INSTRUCTION TO SERVICE

ITS: 5322	
SECTION:	231 Cooling System
WRITTEN BY:	Michael Rooney
SUBJECT:	ISE Cooling Loop Bypass Removal

Figure 2: Hose Layout on Upper/Lower Manifold Headers

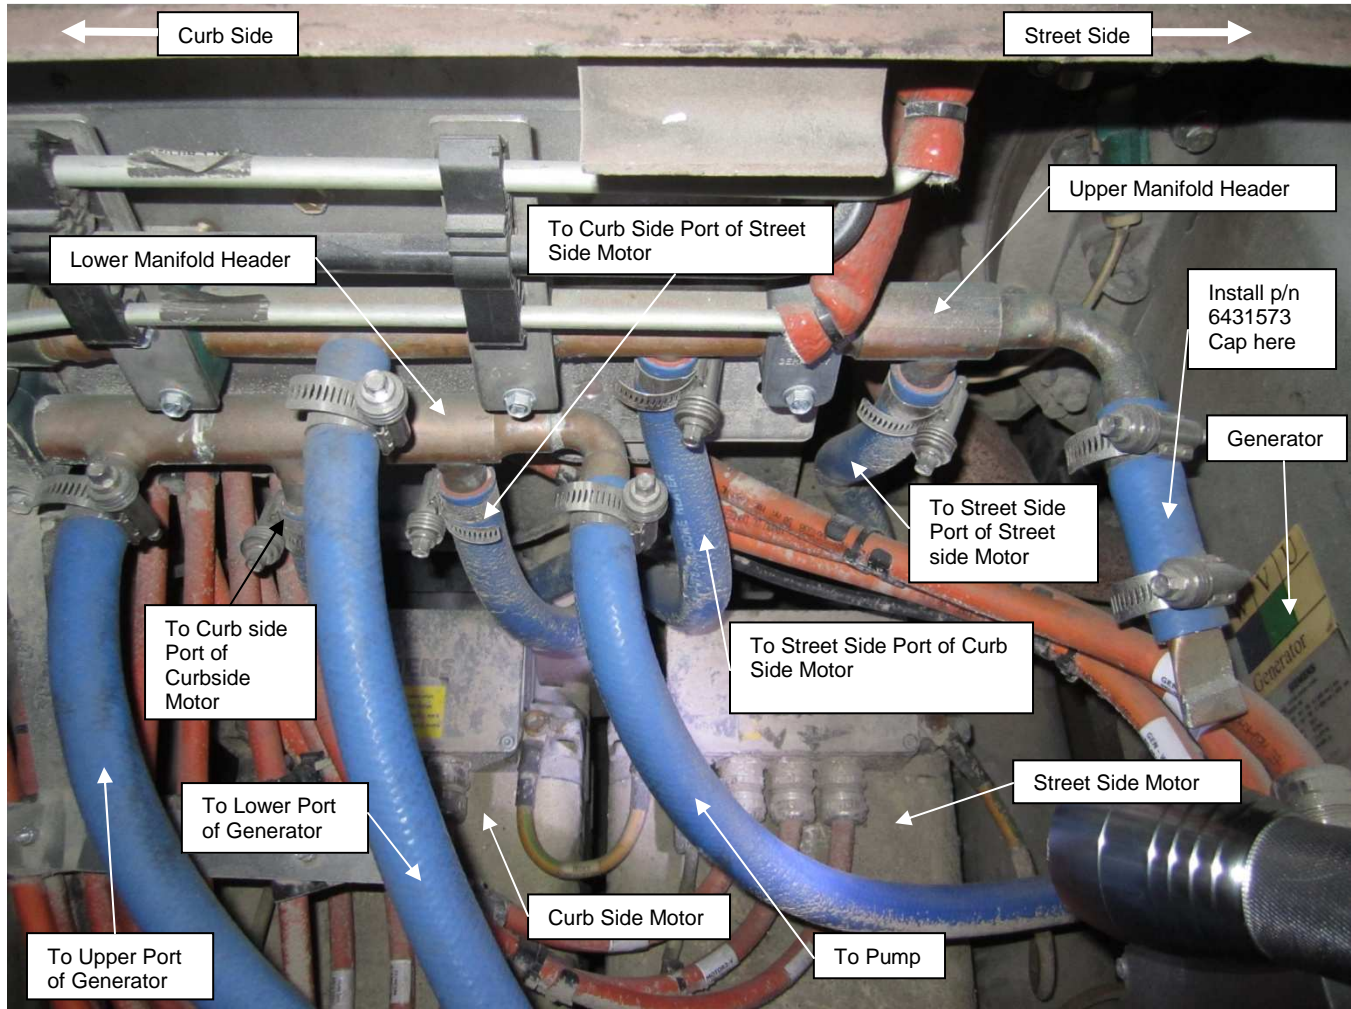
4. Locate the upper and lower coolant manifolds, generator and two electric drive motors. Figure 2.
5. Check to ensure that upper manifold header and components are plumbed as follows: Figure 2.
 - a. Street side branch of the upper manifold header should be closed off.
 - b. Second from street side branch of the upper manifold header should be plumbed to the street side port of the street side electric drive motor.
 - c. Curb side branch of the upper manifold heater should be plumbed to the lower port of the generator.
 - d. Second from curbside branch of the upper manifold header should be plumbed to the streetside port of the curbside electric drive motor.

6. Check to ensure that lower manifold header and components are plumbed as follows: Figure 2.
 - a. Street side branch of the lower manifold header should be plumbed to the coolant pump.
 - b. Second from street side branch of the lower manifold header should be plumbed to the curb side port of the street side electric drive motor.
 - c. Curb side branch of the lower manifold header should be plumbed to the upper port of the generator.
 - d. Second from curbside branch of the lower manifold header should be plumbed to the curb side port of the curbside electric drive motor.

NOTE: Most buses have a bypass hose connecting the upper and lower manifold headers as well as a Y-connection to the electric drive motors which will require modification.

9. If the hose layout at the upper and lower manifold headers does not match Figure 2 and or the bypass hose is present, the hoses will have to be reconfigured.

- a. Drain the coolant from the electronics cooling loop.
 - b. Change the hose connections as necessary to match the configuration shown in Figure 2. Use $\frac{3}{4}$ " hose NF P/N 106197 and hose clamps NF P/N 274935 as needed. Torque hose clamps to 56-62 IN-LBS.

- c. Refill the cooling system.
10. Locate the street side branch of the upper manifold. Figure 2.
 - a. Use a Rotary Tube Cutter to cut the end of the tube to remove the bead.

Figure 3: Hose Layout at Coolant Circulation Pump.

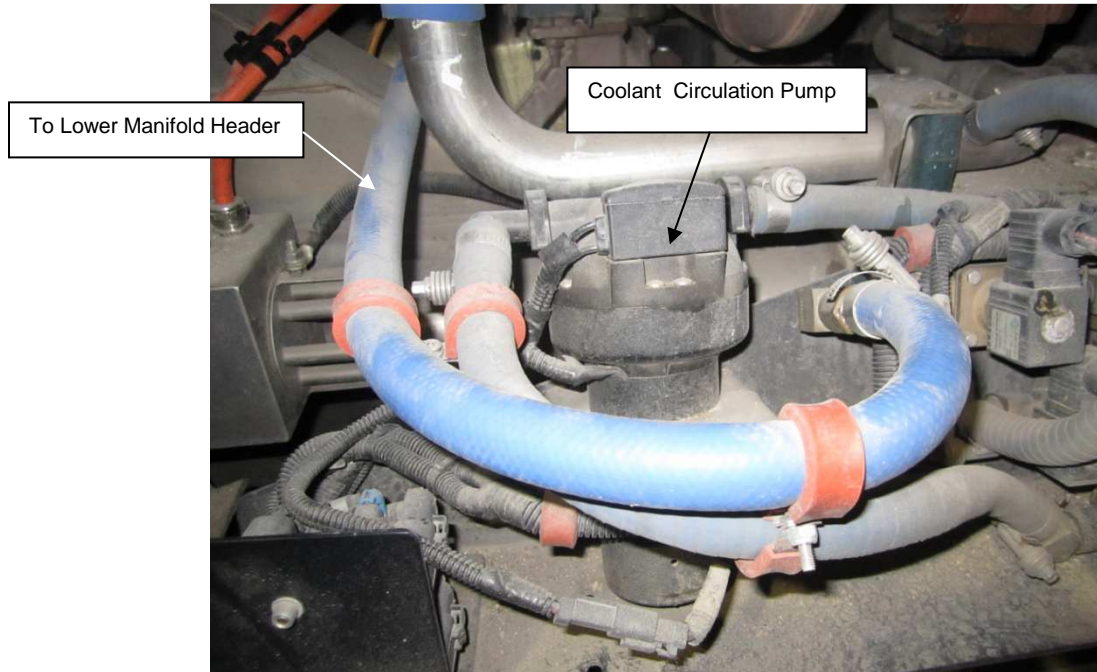
7. Open the curb side rear access door and locate the coolant circulation pump.
8. Check to make sure that the hoses are connected according to Figure 3.

Figure 4: Bypass Tube Plug Installation.

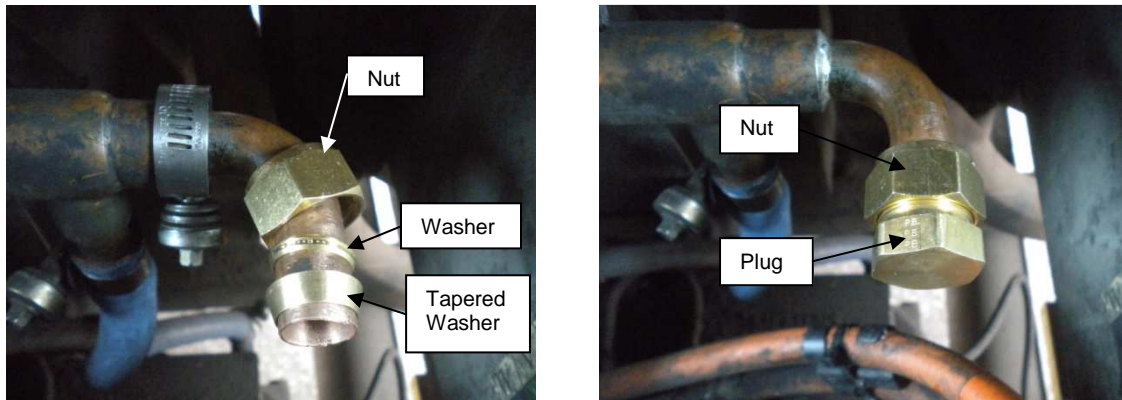
- c. Install the nut, washer and tapered washer from the cap NF P/N 6431573 over the tube. Fig 4, Picture #1.
 - d. Push the plug into the end of the tube and install the nut on the plug finger tight then turn an additional $\frac{1}{4}$ turn. Fig 4, Picture #2.
